Item Name: Crosstube Turning Detail

DART AEROSPACE LTD	Work Order: 108689
Description: Crosstube Assembly	Part Number: D206-667-241
Inspection Dwg: D206-667-241 Rev: C	Page 1 of 2

DRAWING NO. D206-667-241	TITLE CROSSTUBE ASS'Y (206B HIGH AFT)	REV. C	DART AEROSPACE LTD ENGINEERING ORDER		D.E.O. NO. D206-667-241-C-1	SHEET NO. SHEET 1 OF 1	SCALE NTS
DRAWN <i>qp</i>	CHECKED <i>AS</i>	MFG. APPR. <i>MA</i>	APPROVED <i>MA</i>		DE APPR. <i>MA</i>		
DATE 11.07.15	DATE 11.08.22	DATE 11.08.22	DATE 11/08/22		DATE 11.08.22

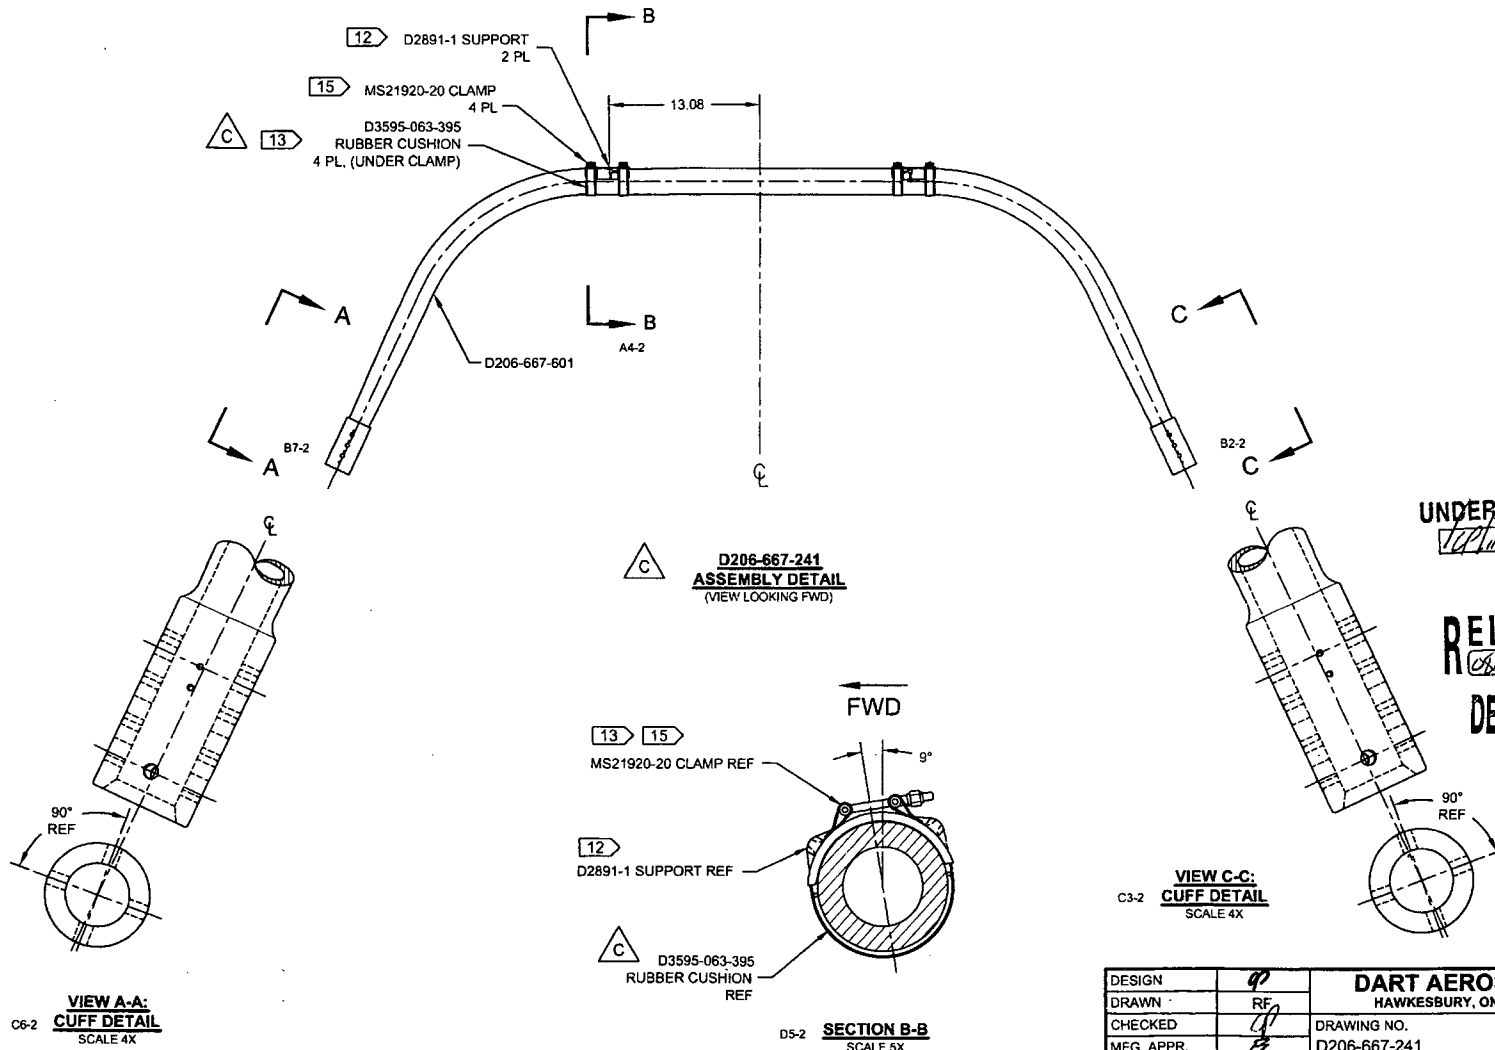
C	REFORMAT/REVISE GENERAL NOTES/PART LIST (ZN D7-1); REORGANIZED VIEWS AND REFORMATTED DRAWING TO CURRENT STANDARDS. D3595-063-395 WAS D2856-400-694 (ZN D6-2 & A5-2); REMOVED REF. & ADD TOLERANCES (ZN C5-3, C4-3, D3-3); RELOCATED FLAG #6 (ZN A7-3) PER NCR 210; MOVED TURNING DETAIL & UPDATED TOLERANCE TO SHEET 4.	RF	08.11.06
B	ADD HOLES FOR COMPATABILITY WITH BHT/AA SKIDTUBES	PH	05.02.04
A	NEW ISSUE	CP	00.11.17
REV.	DESCRIPTION	BY	DATE
DESIGN	RF	DART AEROSPACE LTD HAWKESBURY, ONTARIO, CANADA	
DRAWN	RF	DRAWING NO.	REV. C
CHECKED	RF	D206-667-241	SHEET 1 OF 4
MFG. APPR.	RF	TITLE	SCALE
APPROVED	RF	CROSSTUBE ASS'Y (206B HIGH AFT)	NTS
DE APPR.	RF	COPYRIGHT © 2000 BY DART AEROSPACE LTD THIS DOCUMENT IS PRIVATE AND CONFIDENTIAL AND IS SUPPLIED ON THE EXPRESS CONDITION THAT IT IS NOT TO BE USED FOR ANY PURPOSES OR DISCLOSED OR REPRODUCED TO ANY OTHER PERSON WITHOUT WRITTEN PERMISSION FROM DART AEROSPACE LTD.
